Nine Mile Point
Nuclear Station

November 20, 2003
NMP2L 2104

SUBJECT: Nine Mile Point Unit 2
Docket No. 50-410
Facility Operating License No. NPF-69

**License Amendment Request: Revised Safety Limit Minimum Critical Power
Ratio in Technical Specification 2.1.1.2**

Figure 1 Reference Core Loading Pattern – Cycle 10

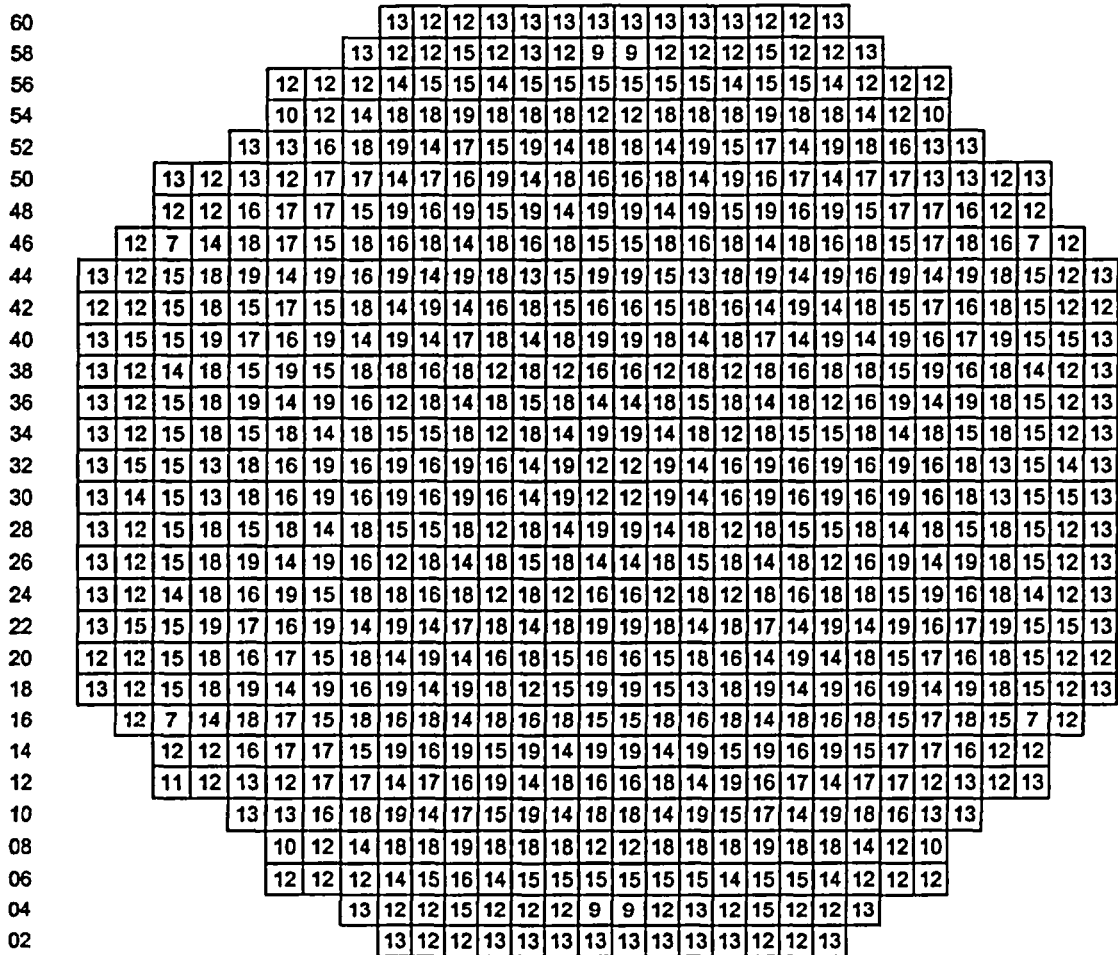
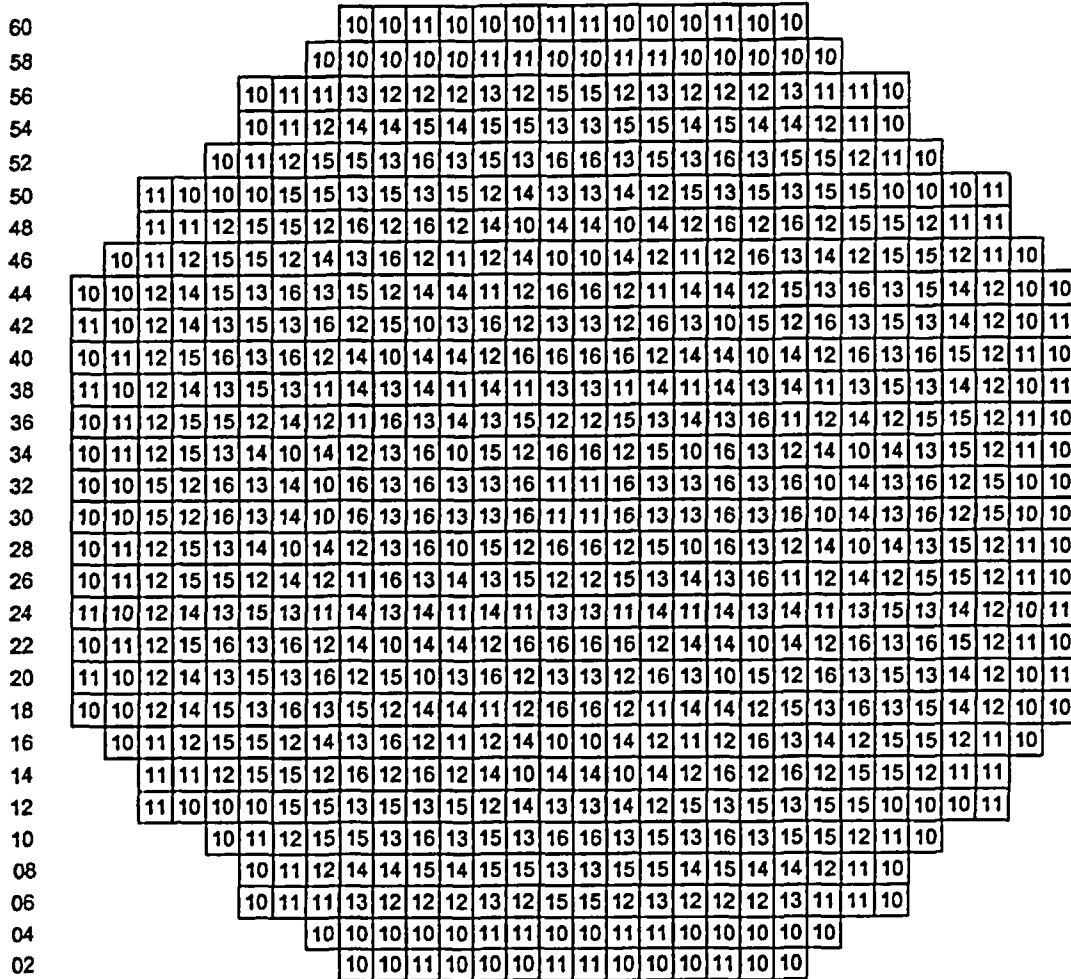
The core loading information for Nine Mile Point Unit 2 Cycle 10 is provided in Figure 1. For comparison the core loading information for Nine Mile Point Unit 2 Cycle 9 is provided in Figure 2. The impact of the fuel loading pattern differences on the calculated SLMCPR is correlated to the values of [[
